**Sent:** 11/06/2019 12:16:00 PM  
**Subject:** Submission for Application Number: Mod2019/0253

Thank you for the opportunity to provide a response to Mod2019/0253 at 24 Lancaster Crescent. I like to advise the following significant concerns.

***DA2016/0963 - Plan – Notification***

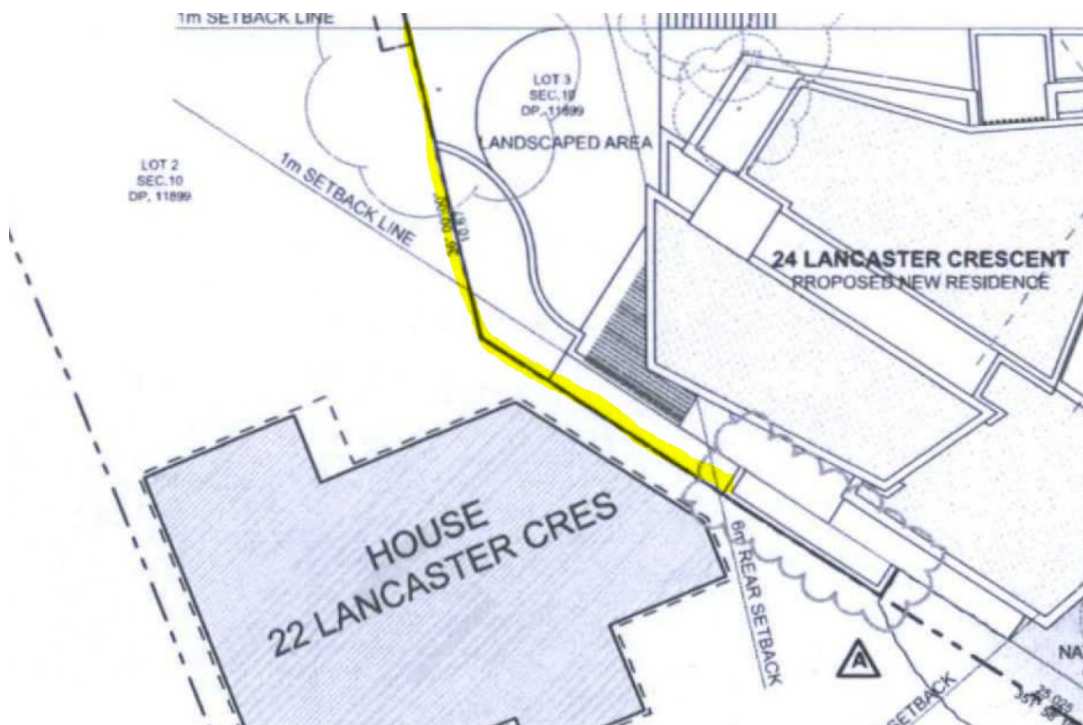
The applicant has already constructed a non-approved masonry boundary fence which ranges from 2.4 to 2.5m high on the south-western boundary and greater than 1.8m on the western boundary of 24 Lancaster Cres with 26 Lancaster Cres. Although this boundary fence height has not been explicitly included in this modification application, the boundary fence has been shown in the document **Mod2019/0253 Plan – Notification**. This fence was absent in the original DA **DA2016/0963 - Plan – Notification** and previous modification **Mod2017/0057 - Plan – Notification**.

As per State Environmental Planning Policy (Exempt and Complying Development Codes) 2008 Subdivision 17 Fences parts 2.33 and 2.34, for residential zones including R2 boundary fences constructed of masonry are not to exceed 1.2m in height. The recently constructed non-approved fences are far in excess of this requirement for an exempt or complying development.

***Mod2019/0253 Plan – Notification***

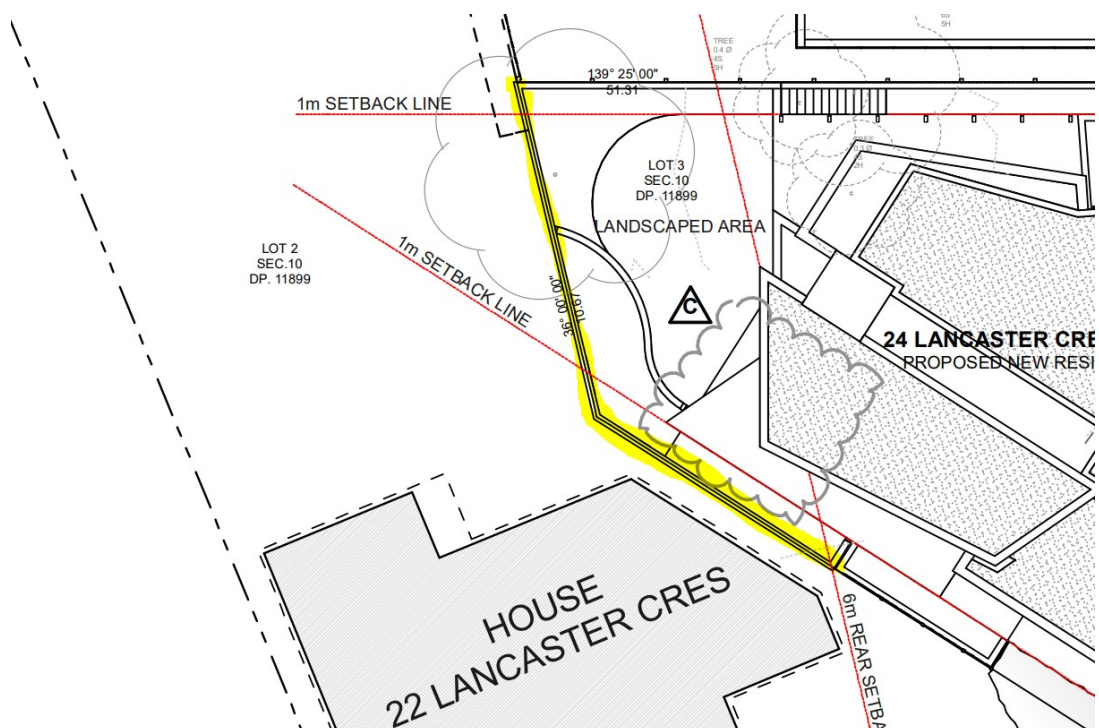
Further, there is no agreement from me as the owner of 26 Lancaster Cres for a masonry fence to be built onto my property as shown in **Mod2019/0253 Plan – Notification**. Should the applicant wish to build an approved and compliant masonry boundary fence this can be done so within the boundaries of 24 Lancaster Cres. I have previously communicated this to the owner along with my preference on keeping the previous wooden pailing boundary fence.
